Report: TAB Report
Function: Test, Adjust, & Balance
Date: 02/26/2026
Completed By: National TAB

PROJECT
03-02-26 Chipotle #5638 Killingly, CT

Project: 03-02-26 Chipotle #5638 Killingly, CT

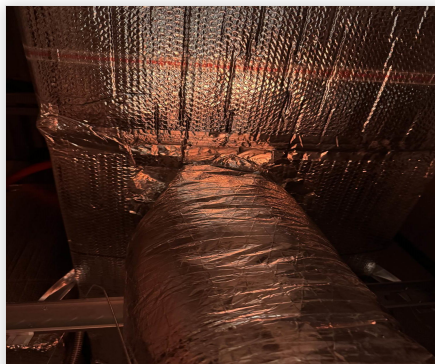
Issue Name : Leak in duct connections
Description : At the connections between the main supply duct and various diffuser runouts in the kitchen (RTU-1) there is leakage. There appears to be no mastic or duct sealant around the connections and there are gaps where air is leaking out. This was apparent at multiple locations and must be sealed.
